# Access Compliance Report Public Rights-of-Way (Curb Ramps)

| Main Street: ROSSMOOR_WAY               |                              | Cross Street: BOSTONIAN_DR |                                         | Location:       | S |
| ADA ID: RPRK211215135231                | Ramp Type: Type 4 - Parallel | Initial Pass/Fail: Fail    | Overall Compliance: No                  | Severity Score: | 2 |

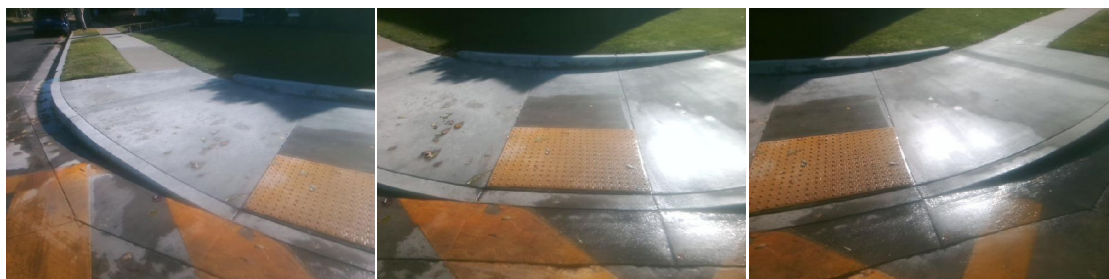
| Compliance | Description                   | Data       | Compliance | Description                   | Data |
|------------|-------------------------------|------------|------------|-------------------------------|------|
| No         | Ramp Cross Slope LT (%)       | 3.2        | Yes        | Ramp Cross Slope RT (%)       | 1.6  |

**Remove & Replace Curb Ramp With Two New Directional Ramps or Equivalent.**

**R304.5.3, STD 1115**
